**No. 10 Reel Ratchet Pawl and
Bevel Gear Replacement Sets****SERVICE BULLETIN
NUMBER SD-179**

OBSOLETE
PAWL & BEVEL GEAR

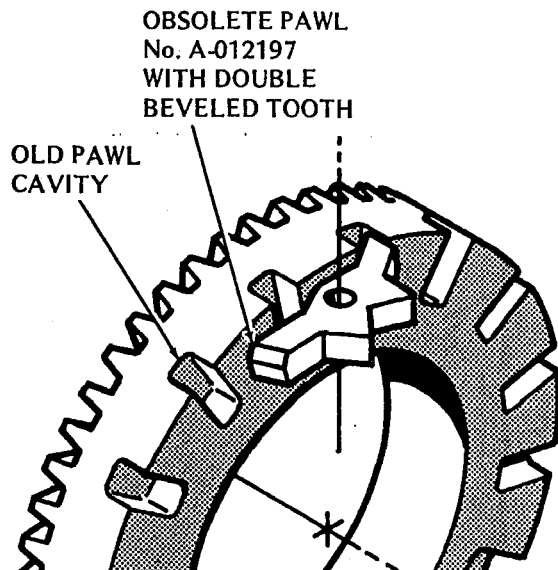
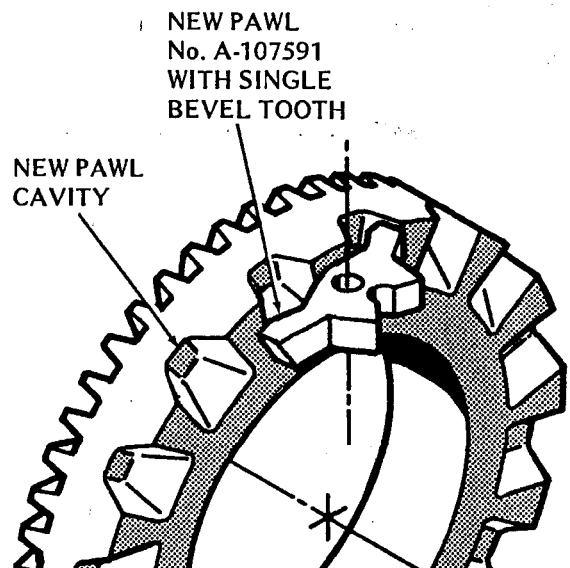
A design change to both the ratchet pawl tooth and mating bevel gear cavity has been made.

DO NOT use the new pawl with obsolete design bevel gears.

When replacing either of these parts, be certain that only newly designed parts are used in combination with one another.
